ADDENDUM No. 4
Request for Competitive Sealed Proposals (CSP)
19CSP060 Renovations at Reilly Elementary School

ADDENDUM NO. 4
TO THE
DRAWINGS AND PROJECT MANUAL
FOR
**RENOVATIONS TO REILLY ELEMENTARY SCHOOL
AUSTIN ISD
AUSTIN, TEXAS**

Addendum #4 (Structural) to Reilly Elementary School for Support of Replacement Rooftop Mechanical Units
 November 29, 2018

2 ROOF PLAN
 SCALE: 1/16" = 1'-0"

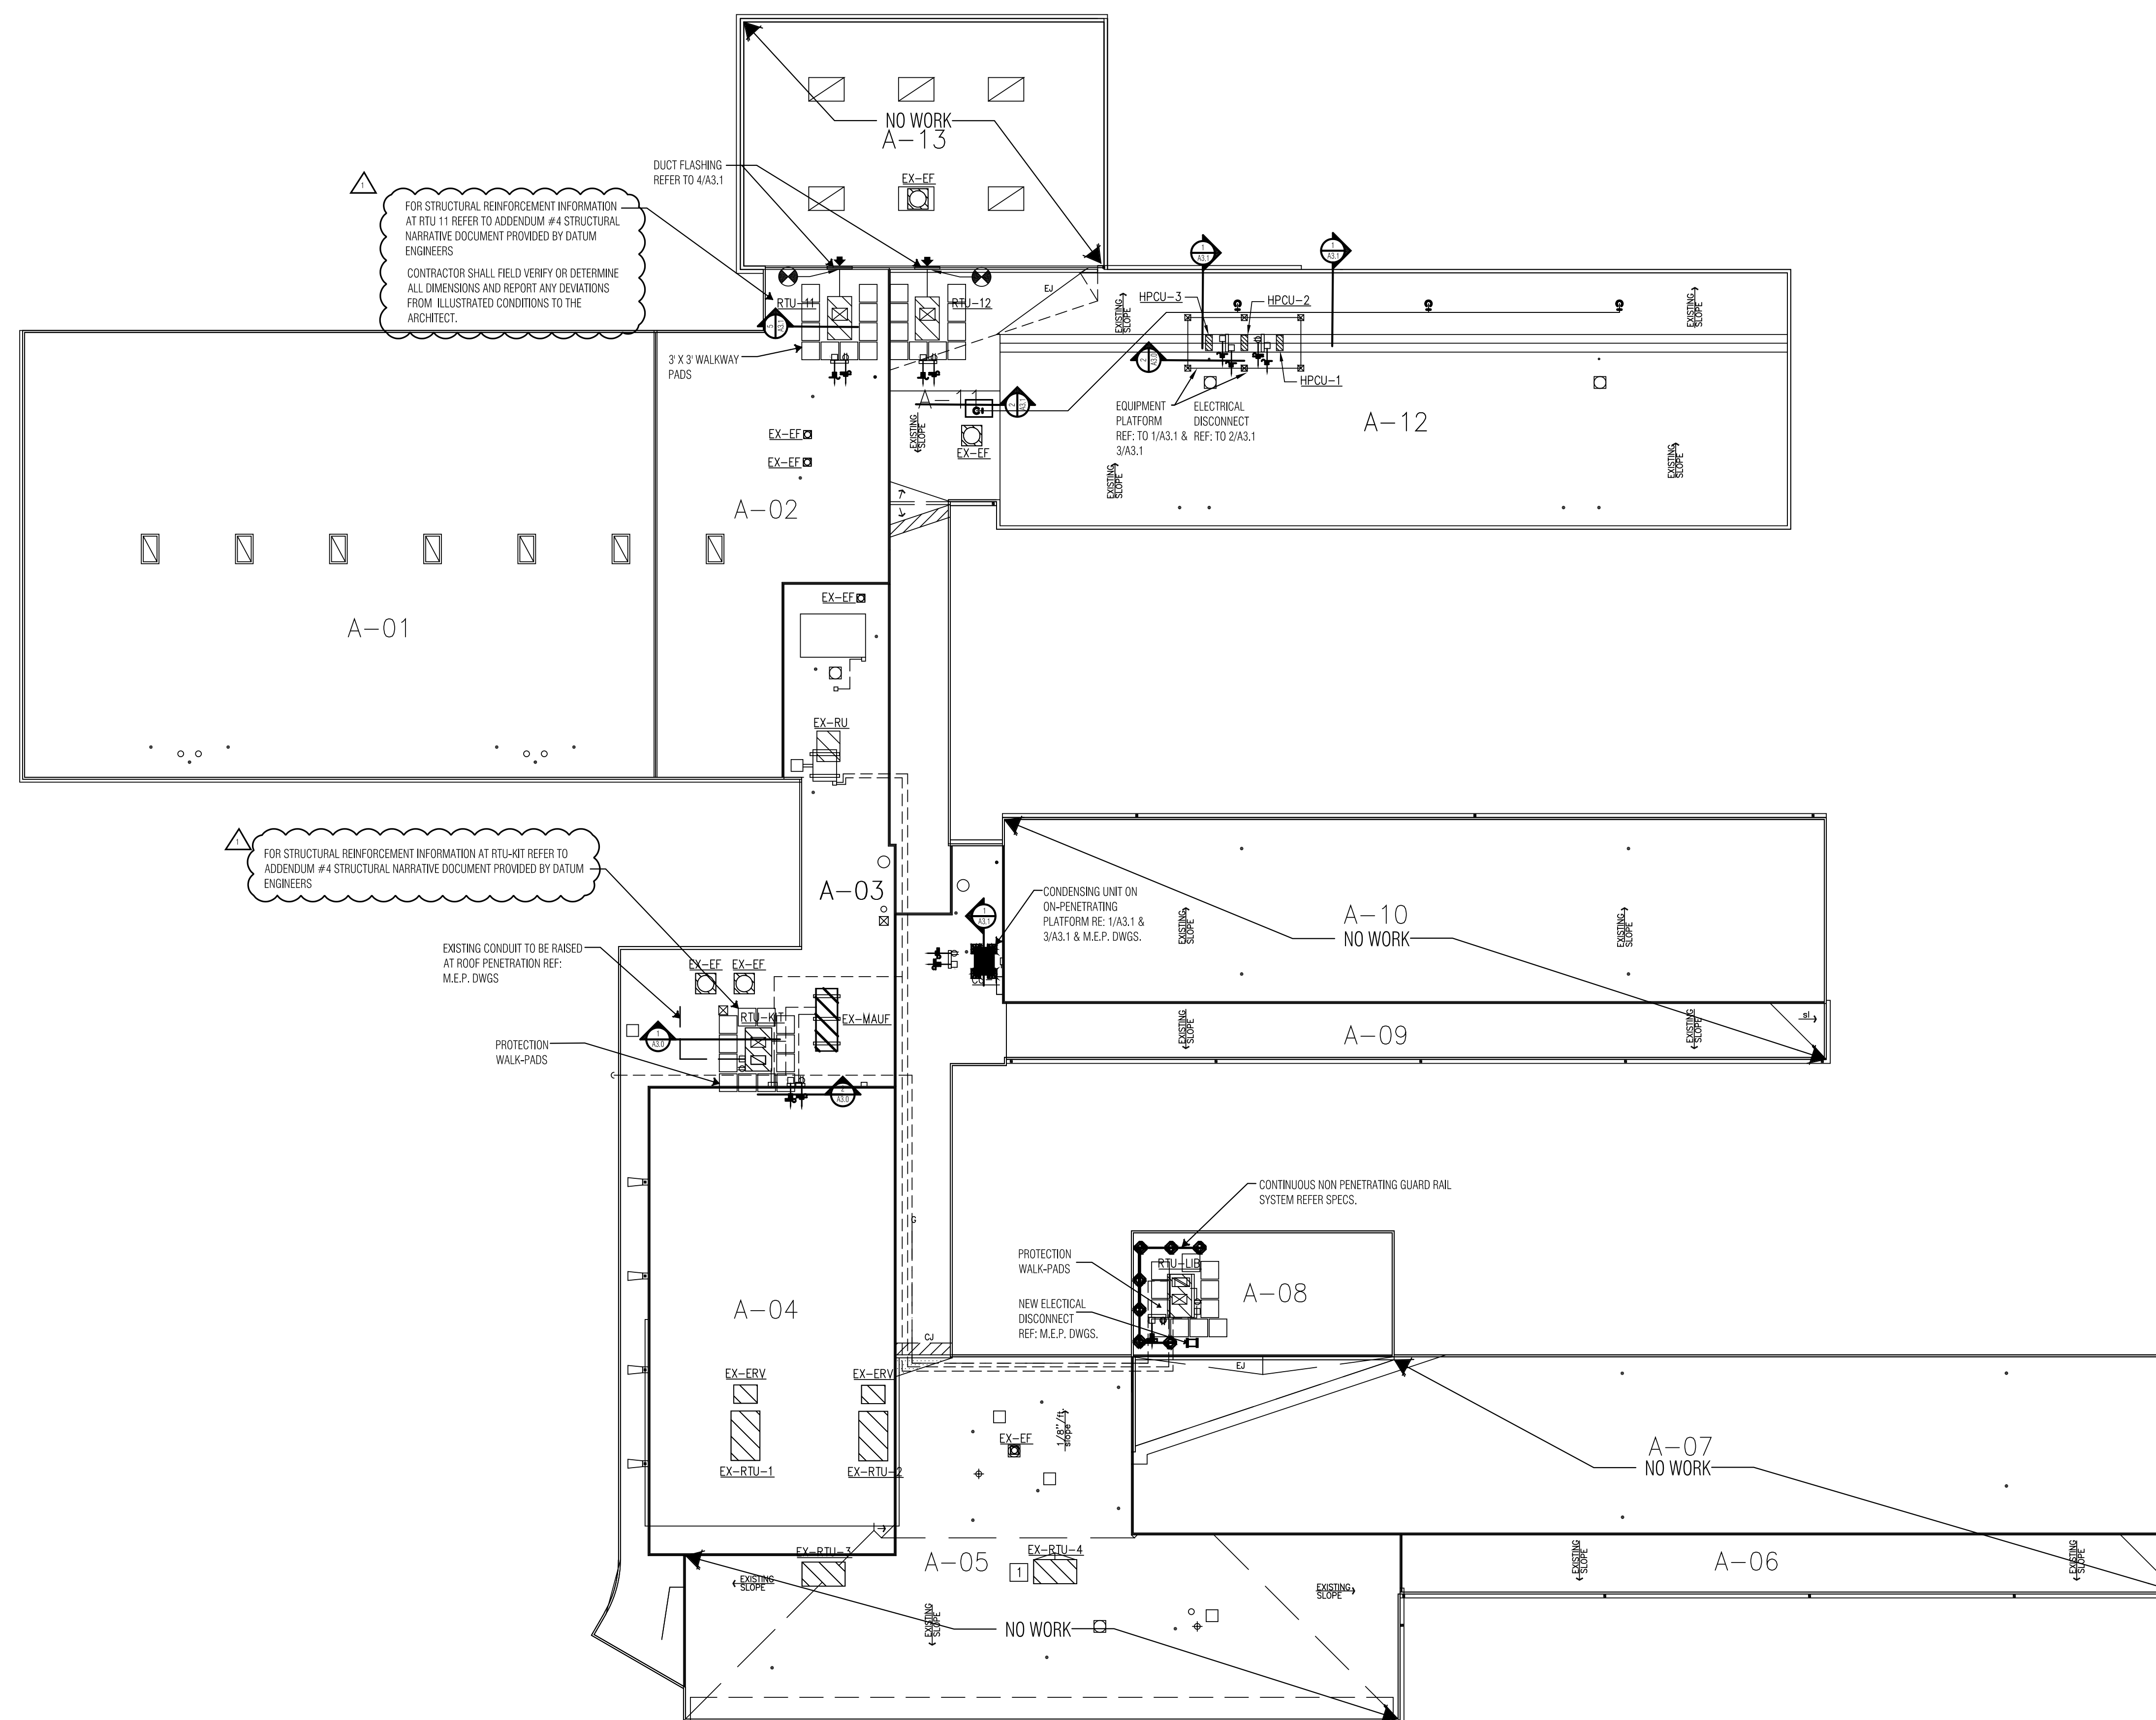
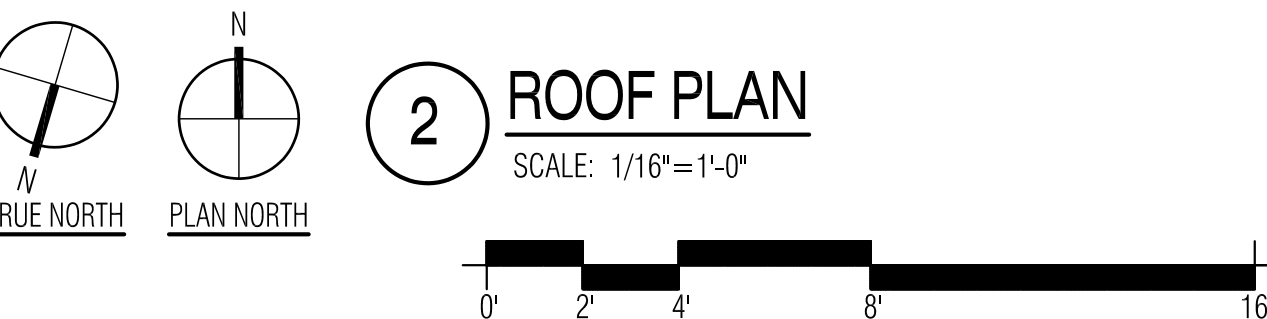
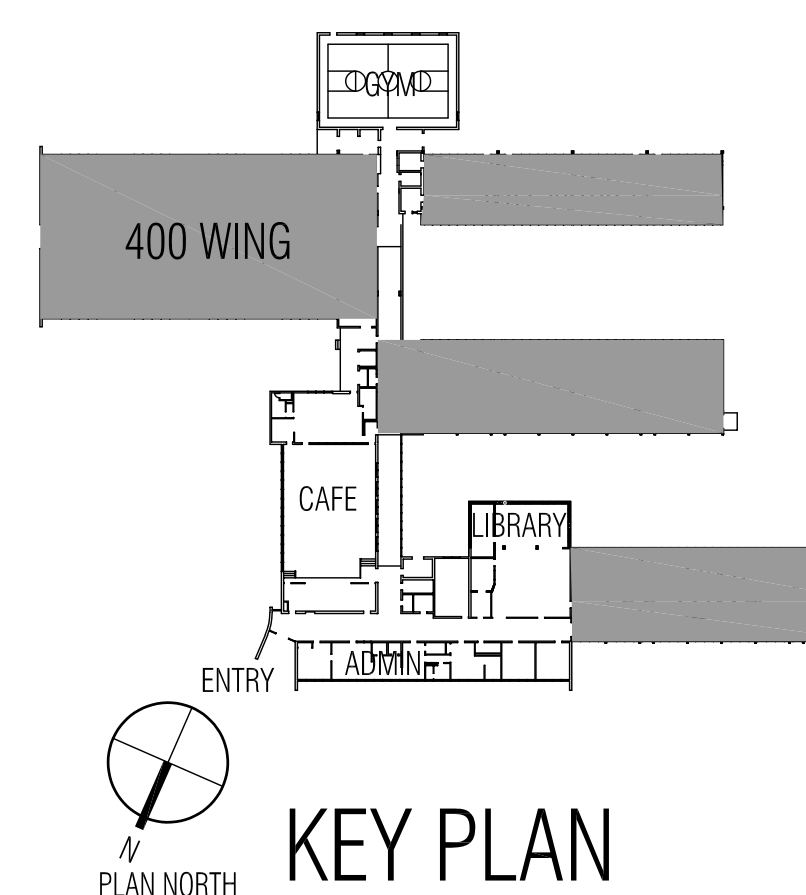
- A. Reference attached revised sheet and attached Structural Narrative - RTU-11 and RTU-KIT, Supplemental Structural Work.

3 BULB TEES TO BE REINFORCED PER NARRATIVE

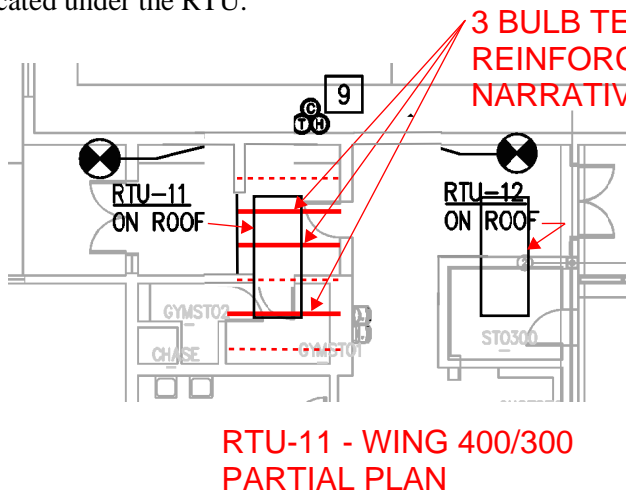
RTU-11 weighs 1311 pounds, and is located adjacent to and northeast of the Gymnasium, on the 1963 addition to the school, referred to as the 400 wing (see attached RTU-11 Partial Plan, below). The existing roof structure in this area consists of a steel frame with steel bulb tee purlins on 33" centers supporting Tectum panels. Provide an HSS2x1x3/16x8'-2" (long dimension vertical), connected to the bulb tee bottom flange with 3/16" x 1" flare bevel groove welds on each side, spaced 12" on center (provide 2" of weld each side at first weld location on each end of tube). These HSS2x1's shall be installed at all bulb tees located under the RTU.

RTU-KIT - CAFETORIUM PARTIAL PLAN

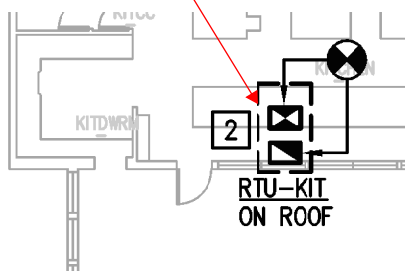
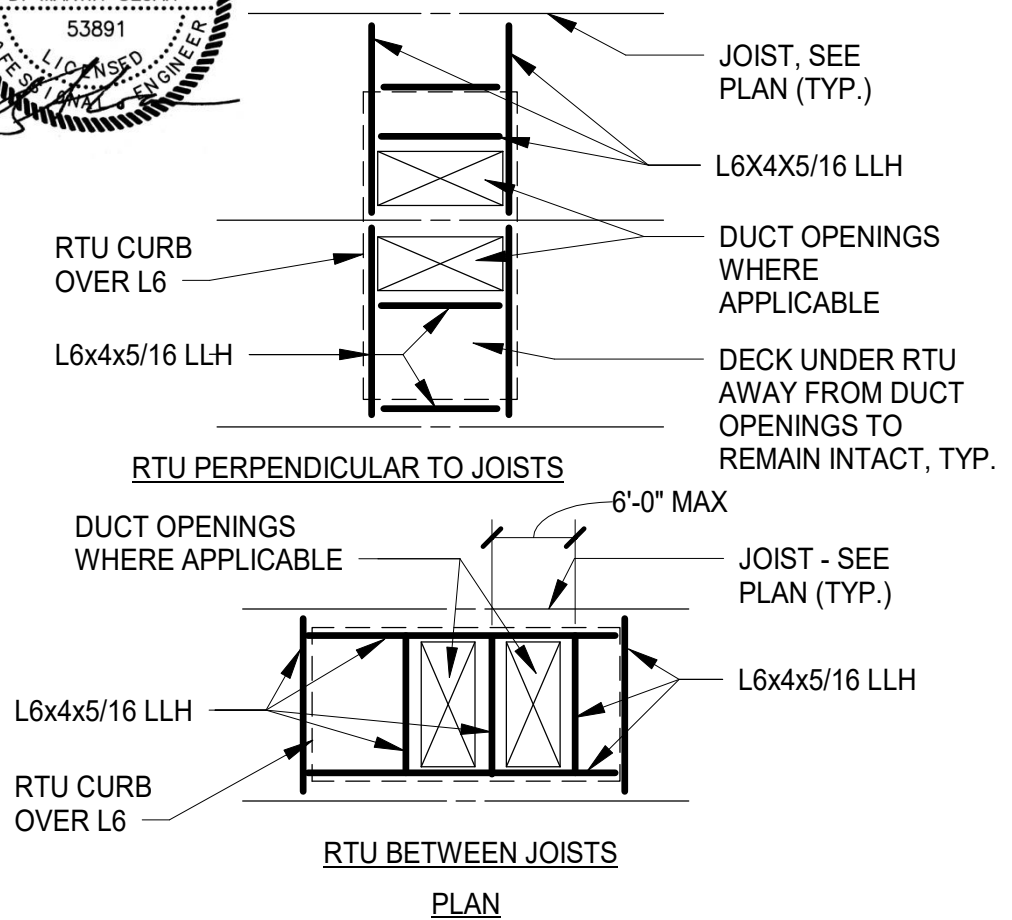
RTU-KIT weighs 966 pounds (35 psf over the footprint of the unit) and is located in the 1956 Cafetorium addition on the east side of the main connecting corridor of the school (see attached RTU-KIT Partial Plan, below). The existing roof structure in this area consists of a steel frame with SJ125 joists on 4'-0" centers, spanning about 22'-0". These joists have been determined to have adequate capacity to support the proposed RTU, but the RTU curb shall be supported by angles and tubes as detailed in the attached RTU-KIT Support Detail @ Kitchen. If the new or relocated curb support angles connect to the existing joist top chords at locations farther than 6" from the joist panel points, then the joist top chords shall be braced as indicated in the attached detail.

SCHMATIC ARRANGEMENT OF RTU
MISC. METAL SUPPORT ANGLES

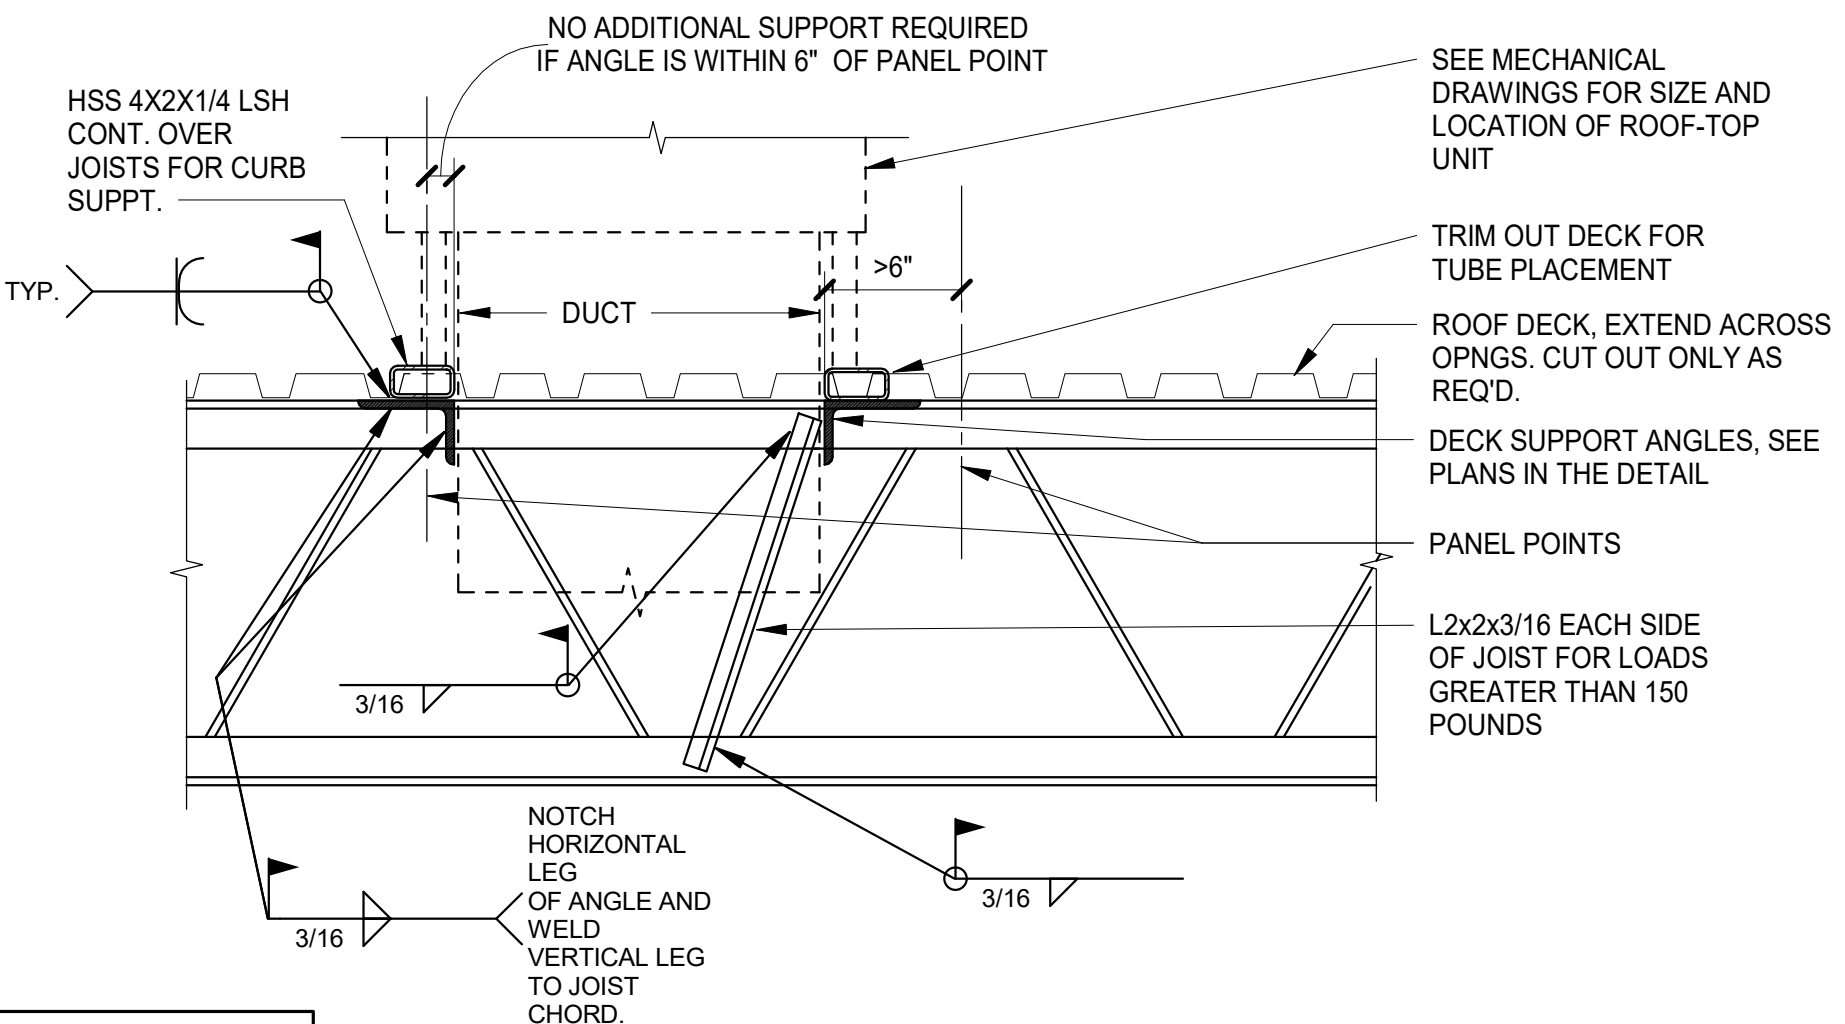
NOTE:
CONTRACTOR TO PROVIDE MISC. METALS COORDINATED WITH THE EQUIPMENT FURNISHED. ARRANGEMENT SHOWN IS SCHEMATIC ONLY AND A FINAL ARRANGEMENT IS TO BE DESIGNED BY THE CONTRACTOR. STRENGTHEN JOIST AS REQ'D. TO COMPLY WITH THIS TYPICAL DETAIL.

1 CONTROL DIAGRAM FOR RTU-11, 12, KIT, LIB
 M6.02 NTS

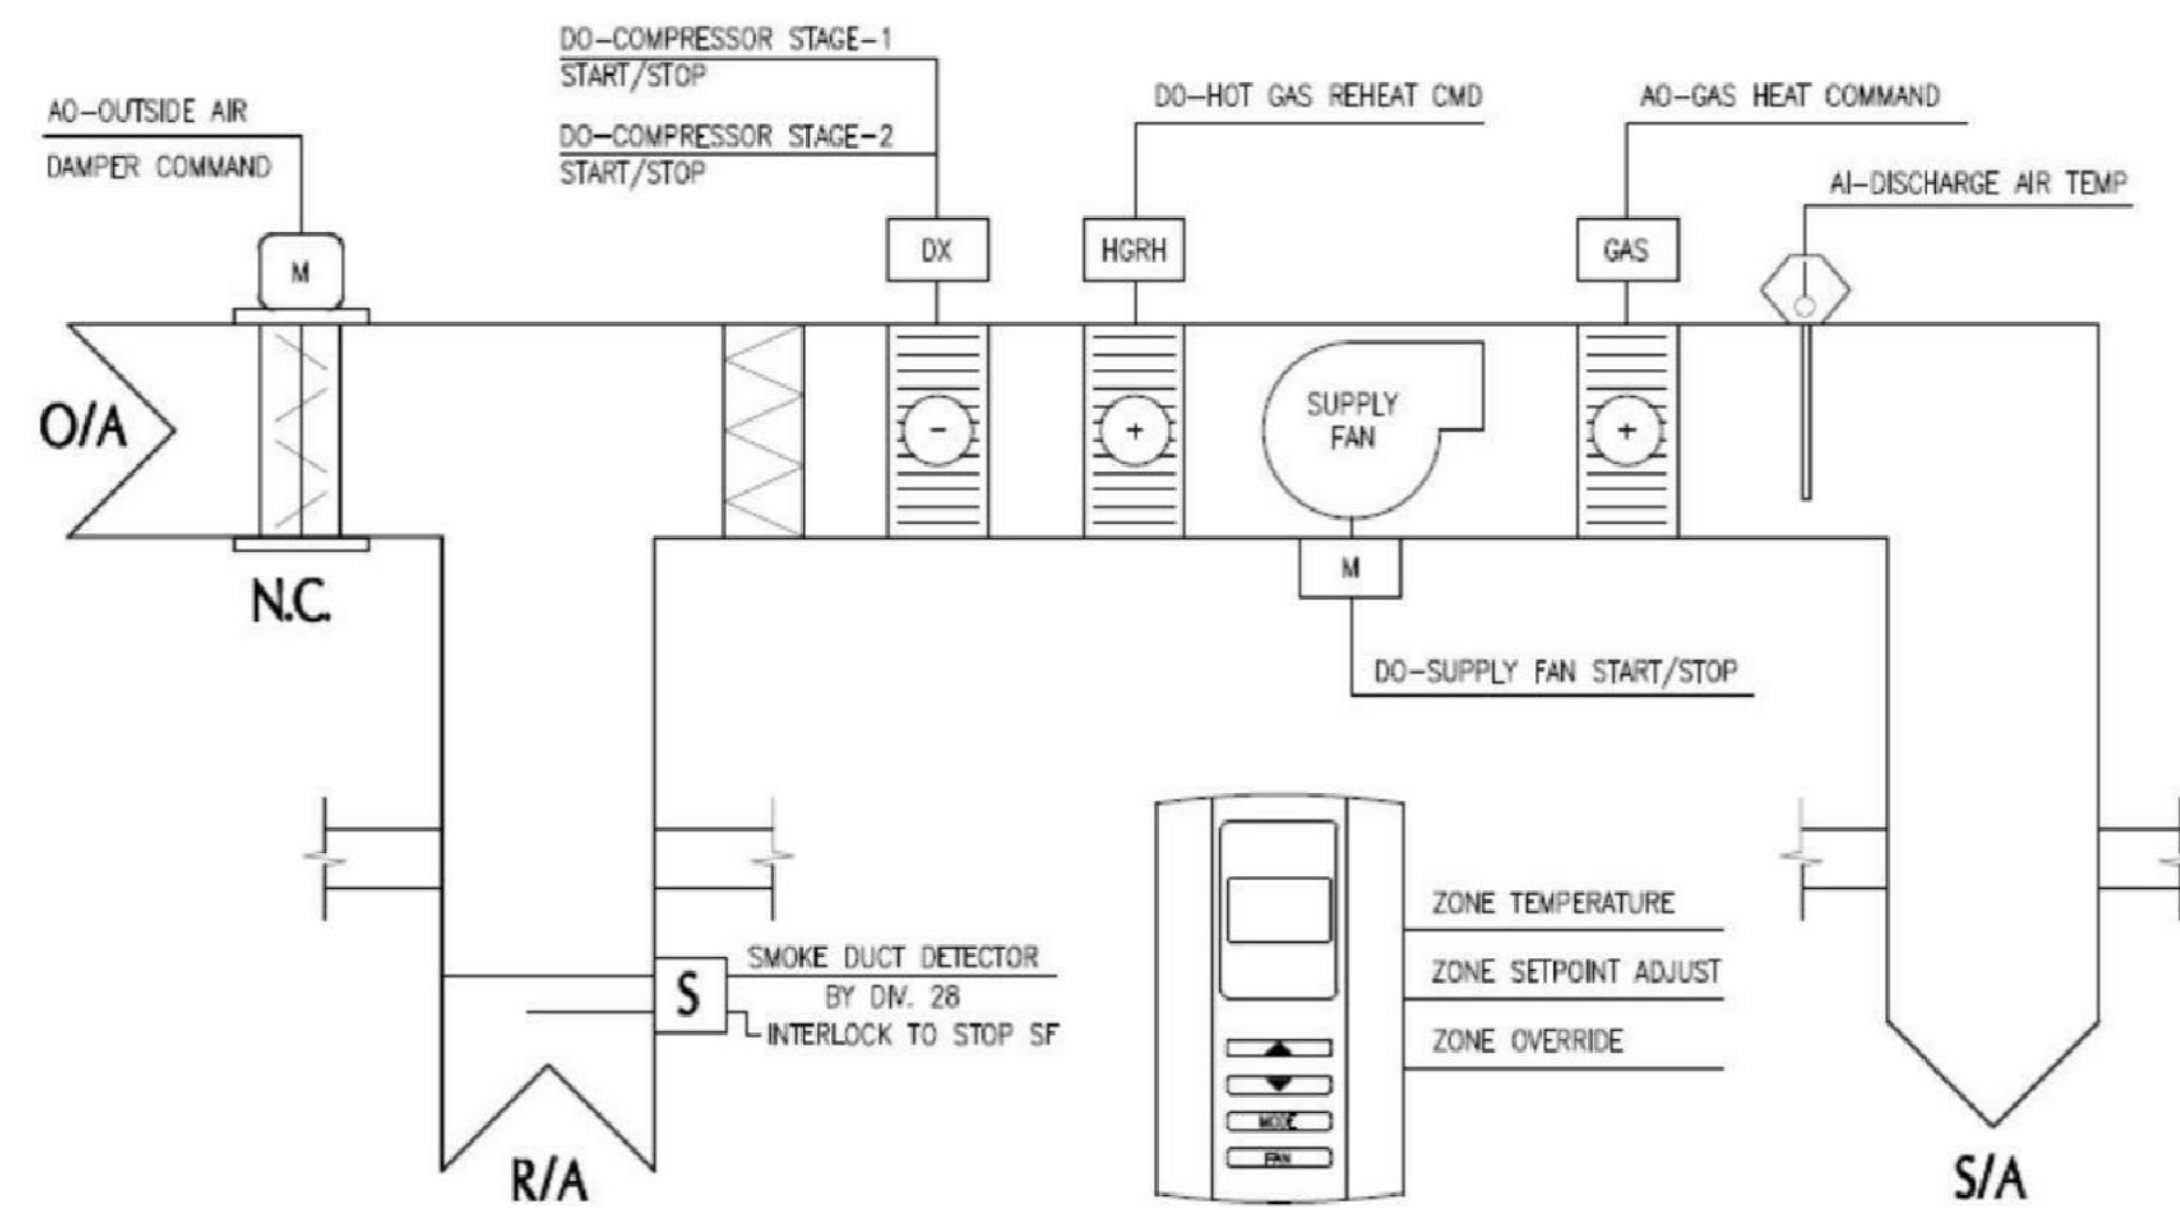
- A. Reference attached revised sheet.
- B. Question: Please verify that per M6.02 & MS.01 (4) new duct detectors should be provided at RTUs 11, 12, Kit, & Lib.
1. Answer: Yes, (4) New smoke duct detectors shall be provided for all (4) new RTU's (RTU's 11, 12, Kit., & Lib.)
- C. Question: Are the new Heat pump units and AH for the MDF to be stand-alone from the DDC controls?
1. Answer: Yes, the new heat pumps and air handler serving MDF room shall be stand-alone from the DDC controls.
- D. Additional changes include: New rooftop units are to be provided with BACnet capability instead of LON as previously specified.

CONTRACTOR SHALL FIELD VERIFY AND LOCATE EXISTING JACE WITHIN BUILDING FOR UTILIZING WITH NEW EQUIPMENT INSTALLED. PROVIDE A NEW BACNET COMMUNICATION CARD AS REQUIRED FOR NEW EQUIPMENT BEING CONNECTED TO THE EXISTING JACE. CONTRACTOR SHALL PROVIDE ADDITIONAL LICENSES REQUIRED TO ACCOMMODATE THE ADDITIONAL DEVICE POINTS AND NODES BEING ADDED TO THE EXISTING JACE.
